Well Name	Well Number	US Well Number	Lease Number	Case Number	Operator
TAILS CC 10_3	35H	3001548965	NMNM081616	NMNM081616	OXY USA
TAILS CC 10_3	31H	3001548881	NMNM81616	NMNM81616	OXY USA
TAILS CC 10_3	32H	3001548880	NMNM81616	NMNM81616	OXY USA
TAILS CC 10_3	36H	3001548964	NMNM081616	NMNM081616	OXY USA
TAILS CC 10_3	312H	3001548930	NMNM81616	NMNM81616	OXY USA
TAILS CC 10_3	33H	3001548879	NMNM81616	NMNM81616	OXY USA
TAILS CC 10_3	38H	3001548877	NMNM81616	NMNM81616	OXY USA
TAILS CC 10_3	34H	3001548959	NMNM081616	NMNM081616	OXY USA

Notice of Intent

Type of Action: APD Change

CAMERON ADAPT WELLHEAD - NM

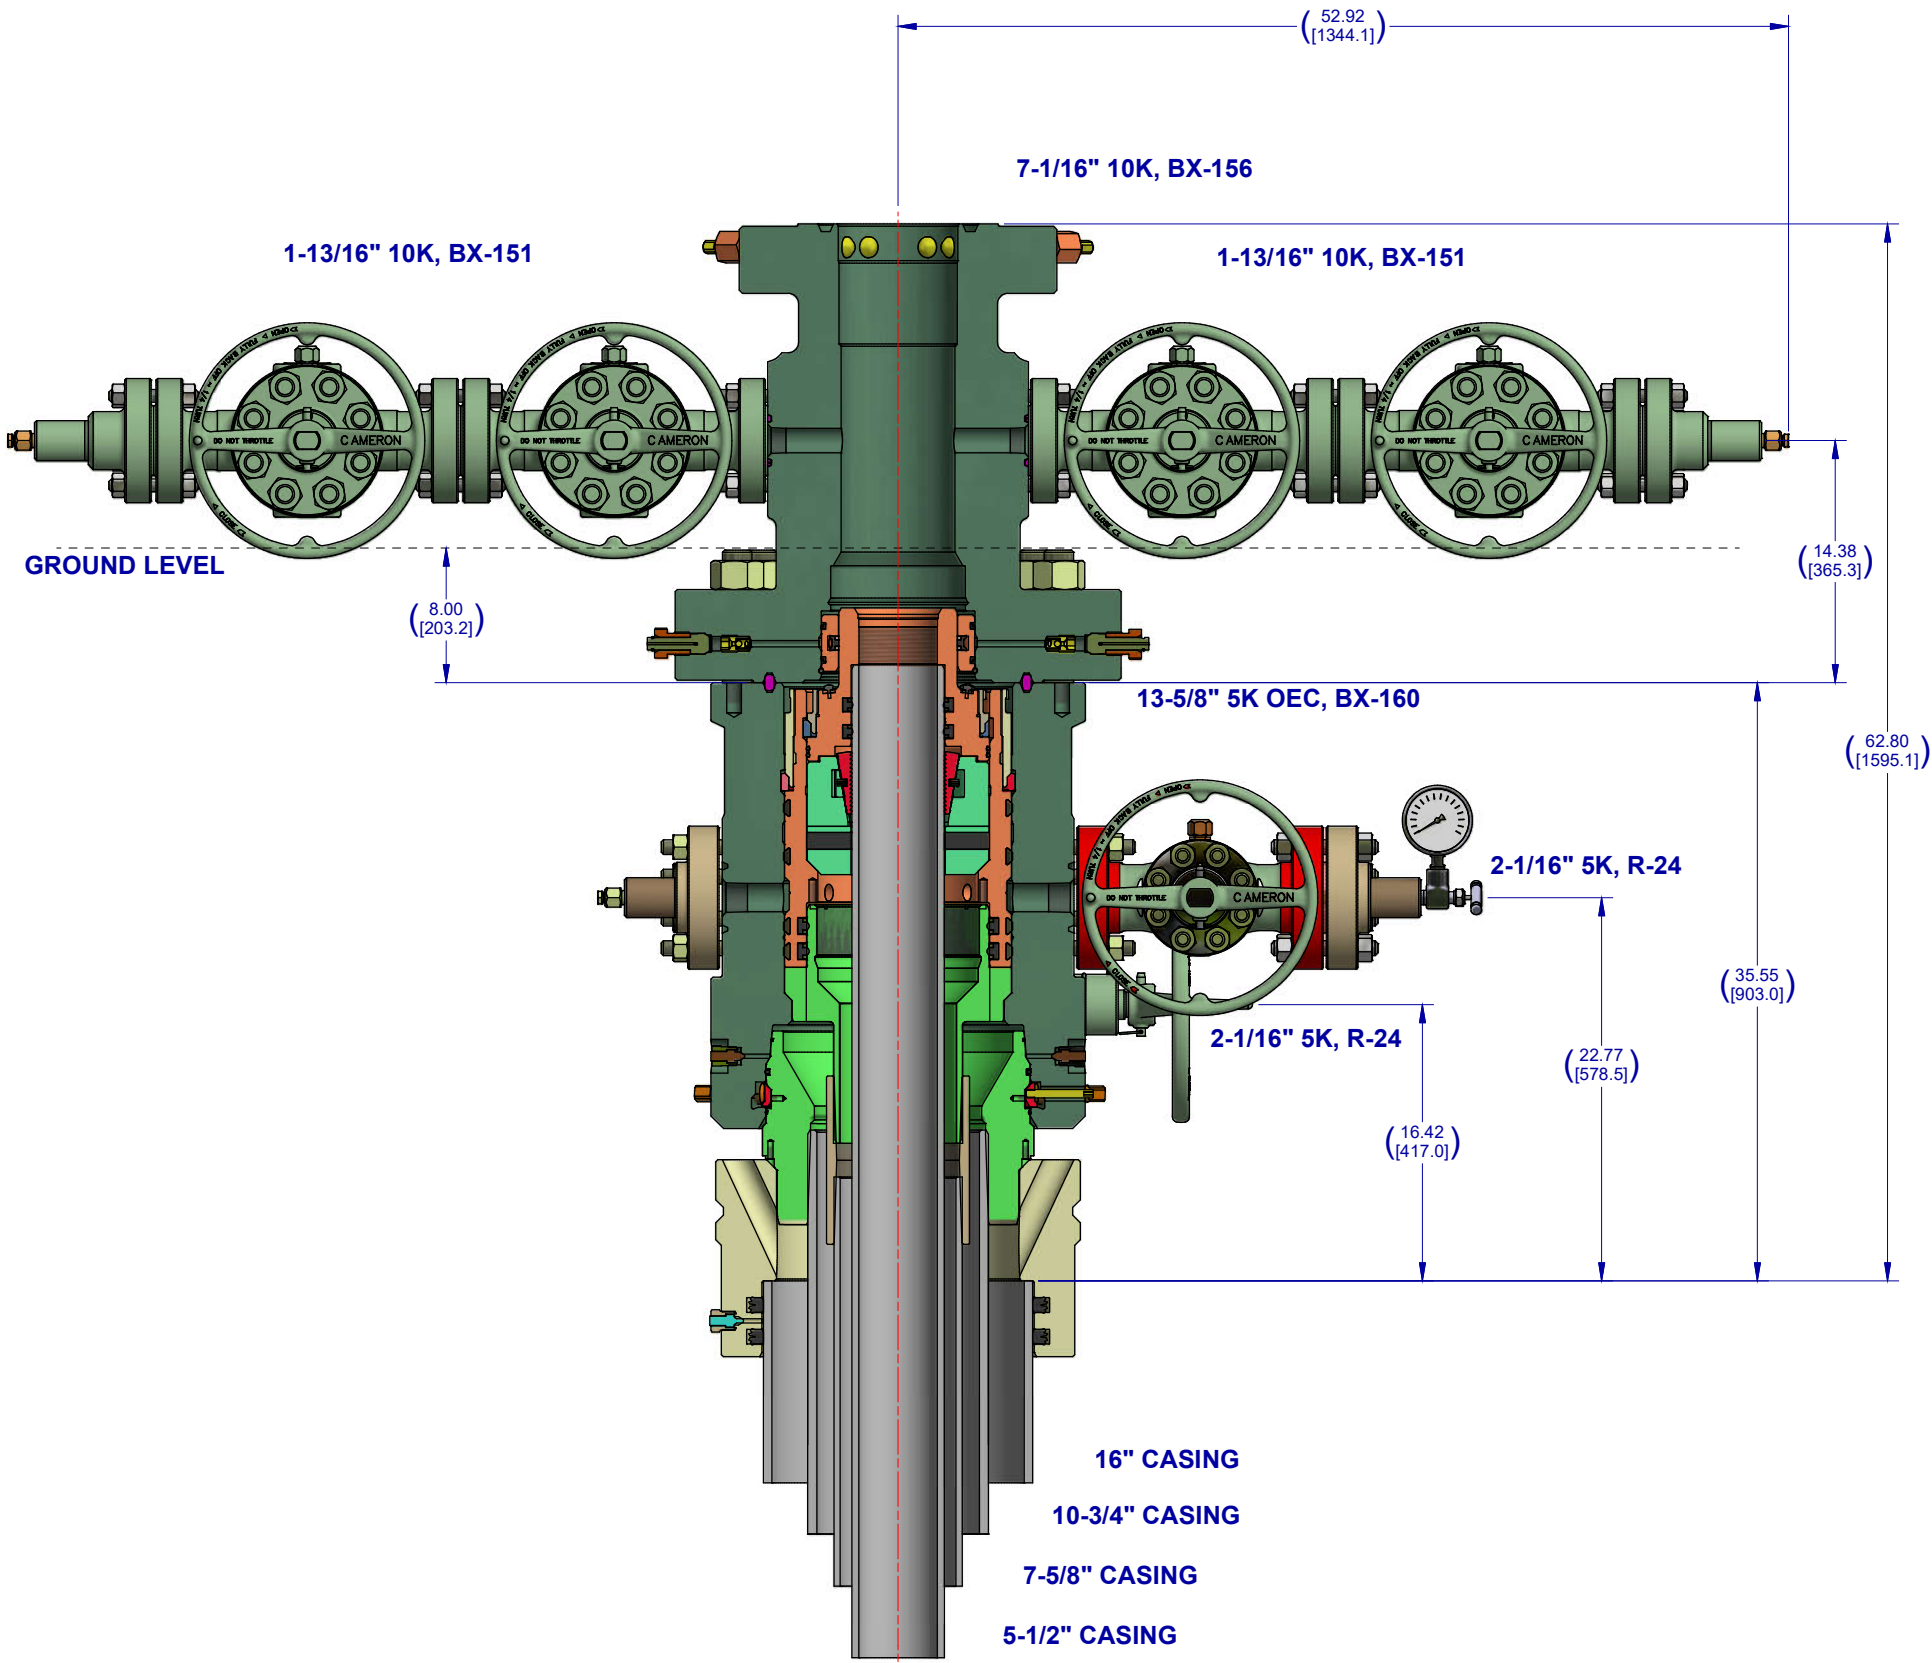
- All Wellhead Components have API monogram
 - Casing Bodies, Hangers, Tubing Spools, Valves, Slips, Ring Gaskets
 - Packoffs are not monogrammed per API
- Top connection of ADAPT casing head is not an API flange (classified as other end connector aka “OEC”),
 - Uses standard API ring gasket and has been certified and vetted by API
- R-type ring gaskets on casing head outlet valves
 - You could run RX if you wanted to
- BX-type ring gaskets for tubing spool + outlet valves

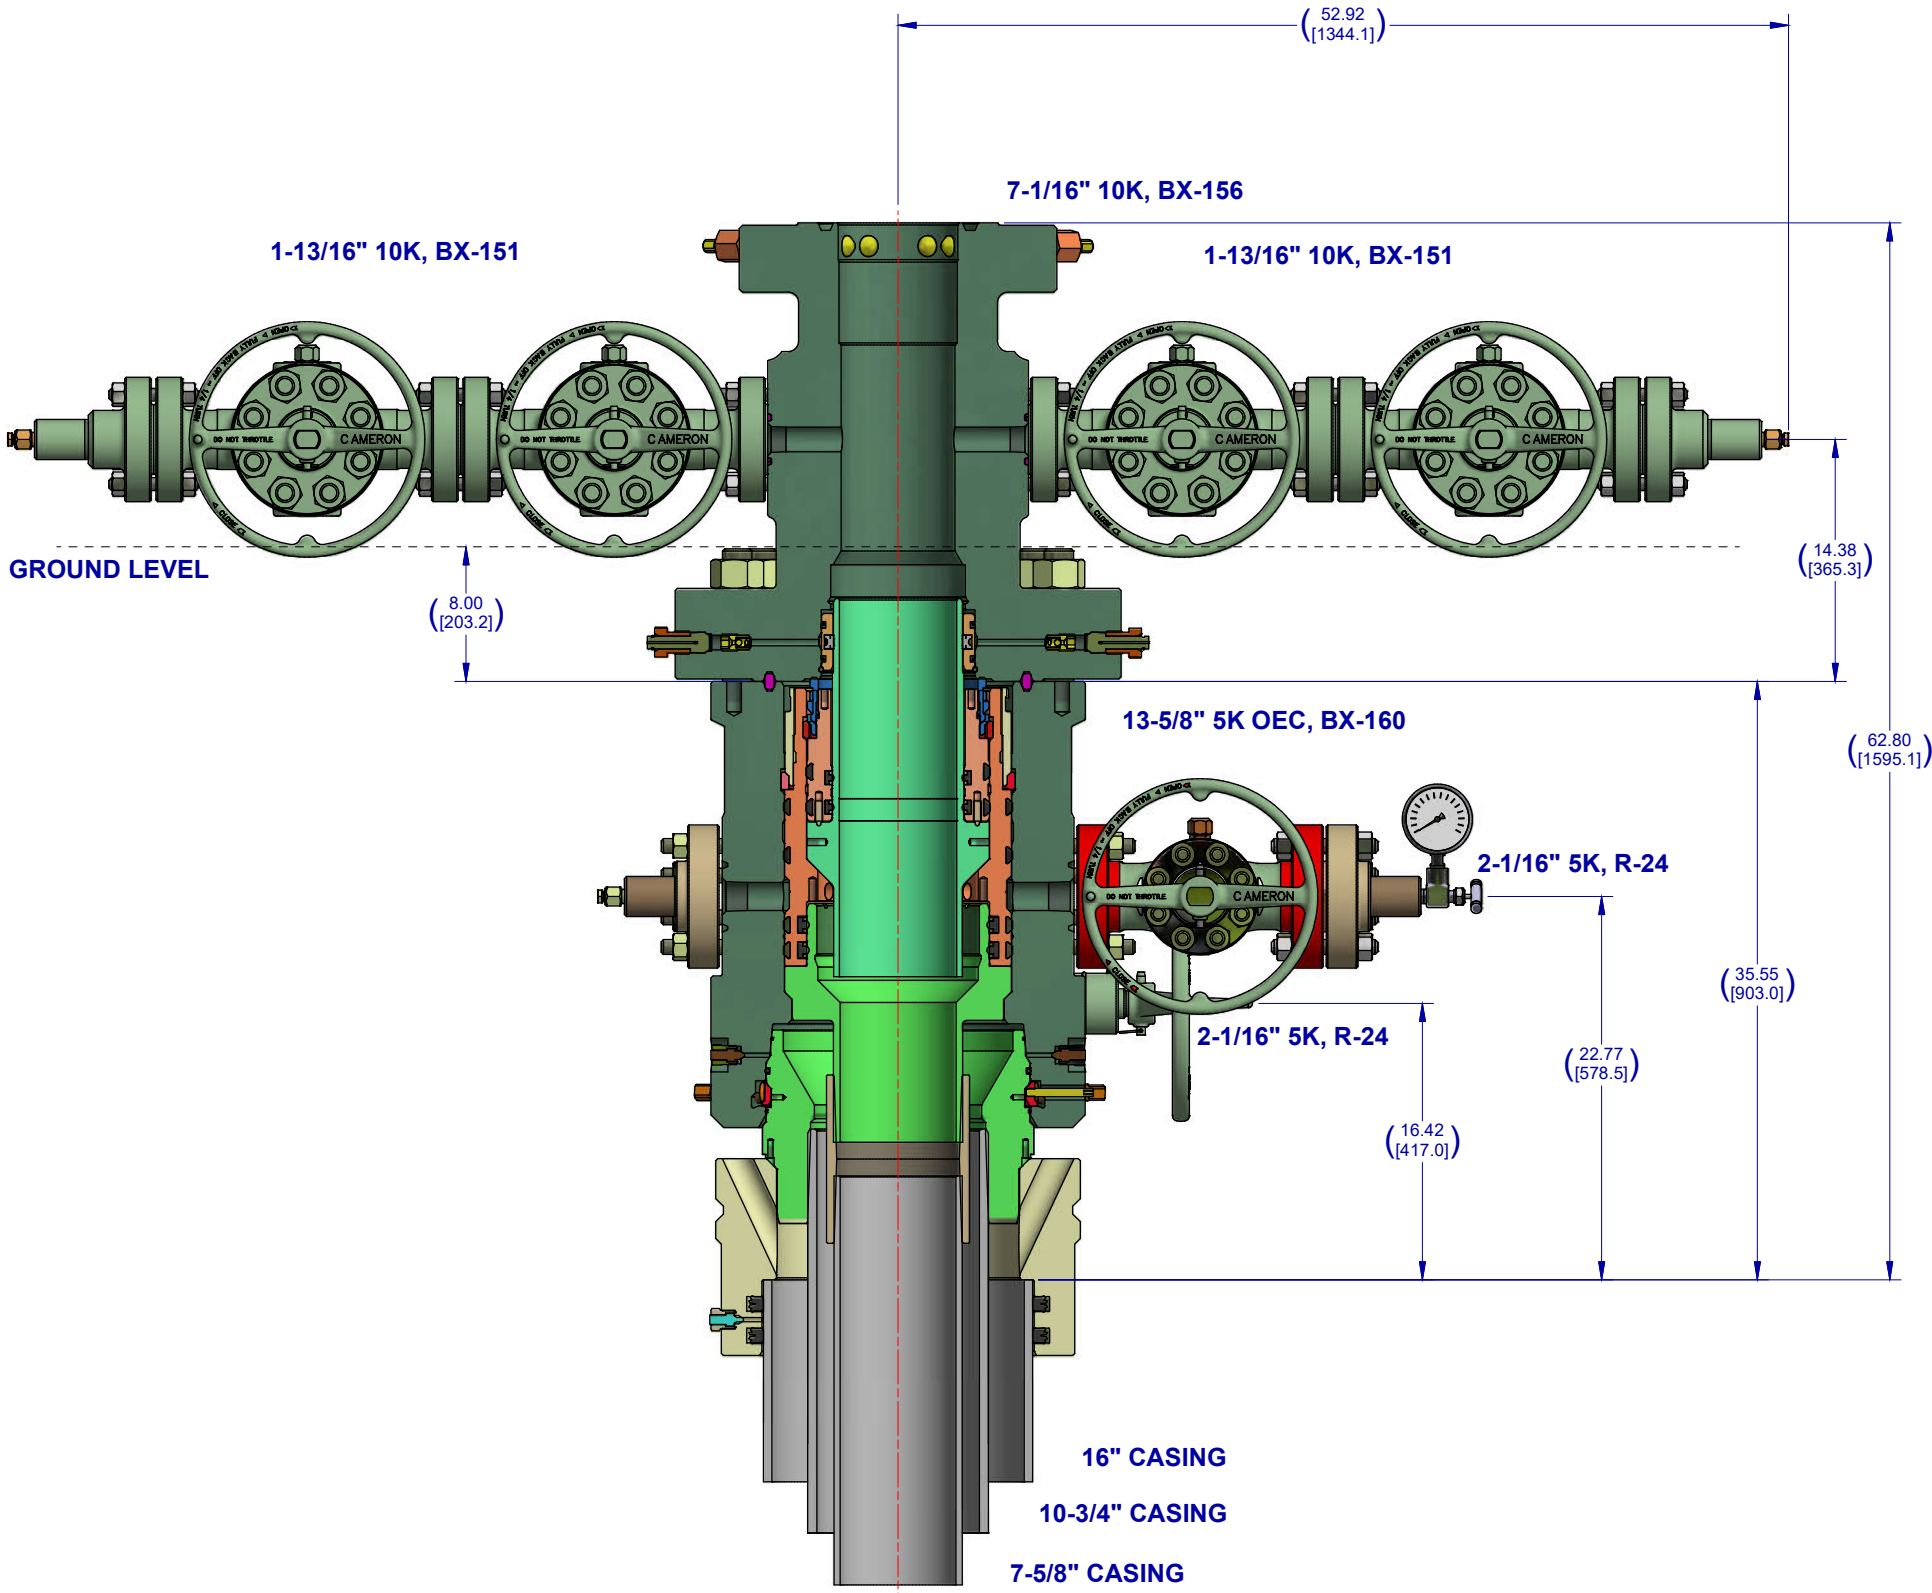
Procedure Description: OXY USA Inc. respectfully requests approval to amend the subject well AAPD wellhead design. See the attached diagram of the planning wellhead system for the Tails wells. The drilling rigs are currently moving onto the well pads to being drilling. OXY will use Cameron ADAPT wellhead system that uses an OEC top flange connection. This connection has been fully vetted and verified by API to Spec 6A and carries an API monogram. See the attached wellhead slide.

Disposition: Approved
